GROUP	MODEL
ELE	2024MY EV9 (MV)
NUMBER	DATE
327 (Rev 1, 7/10/2024)	June 2024

## TECHNICAL SERVICE BULLETIN

### SERVICE ACTION: RSPA LOGIC IMPROVEMENT (SA558)

**ROM ID INFORMATION TABLE:**

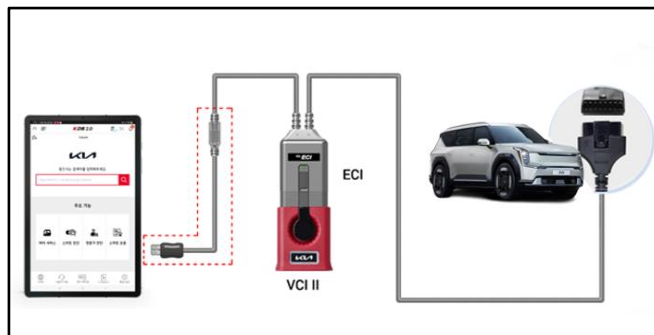
Upgrade Event #719 (MCU) and #720 (VPU)

Event No.	System	Comment	ECU P/No.	ROM ID	
				Previous	New
719	ADAS (MCU)	No Lidar Normal Mirror	99910 D0000	1.03 1.04 1.05 1.06 1.07 1.08	1.09
720	ADAS (VPU)	No Lidar Normal Mirror	99910 D0000	1.03 1.04 1.05 1.06 1.07 1.08	1.08

*To verify the vehicle is affected, be sure to check the Calibration Identification of the vehicle's ECM ROM ID and reference the Information Table as necessary.*
